FINAL PLAT

OAK RIDGE THIRD ADDITION

RE: S/D 99-91 -- One-Step Final Plat of OAK RIDGE THIRD ADDITION

STAFF REPORT
(One-Step Final Plat Approved 1/06/2000)

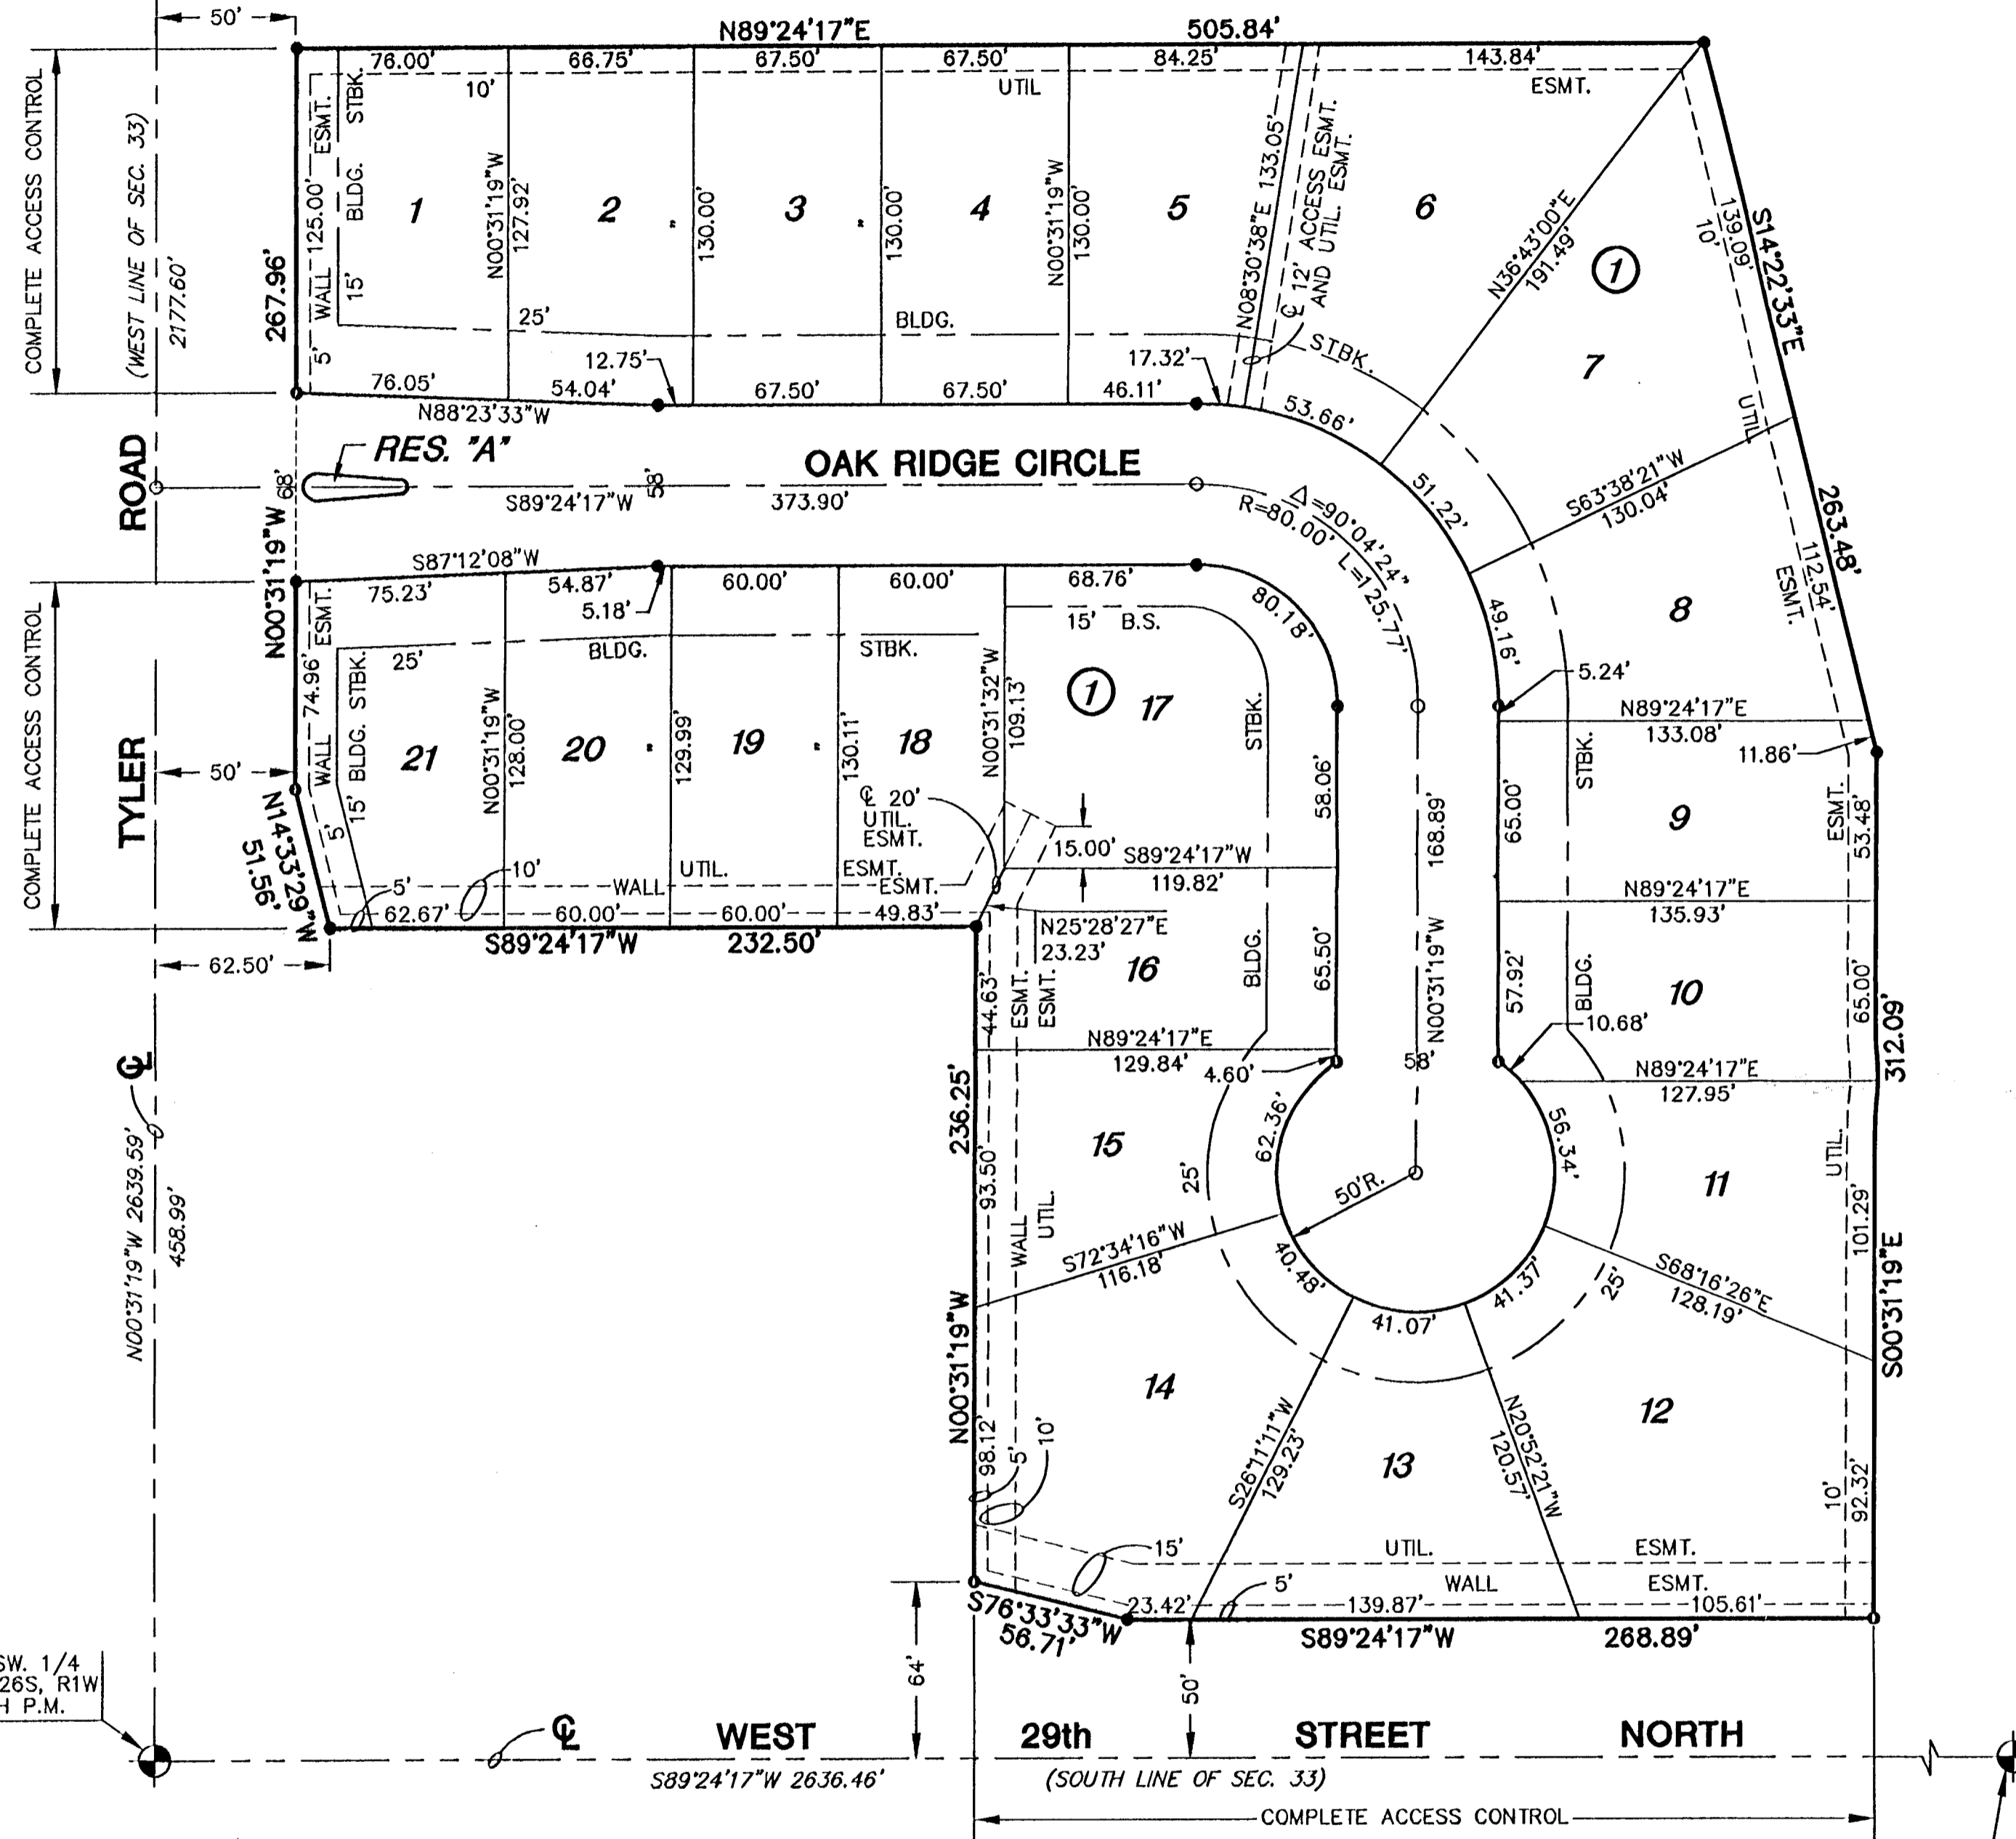
- F. The County Surveyor requests the closure of all of the lots.

G. The tie point at the northwest corner of the plat should read "SW ¼".

H. The legal description appears to be incomplete.

I. The street right-of-way dimensions need to be added at the taper to the section lines.

J. The distance from the tie points to the property needs to be denoted.

- F. The County Surveyor requests the closure of all of the lots.
- G. The tie point at the northwest corner of the plat should read "SW ¼".
- H. The legal description appears to be incomplete.

- I. The street right-of-way dimensions need to be added at the taper to the section lines.
- J. The distance from the tie points to the property needs to be denoted.
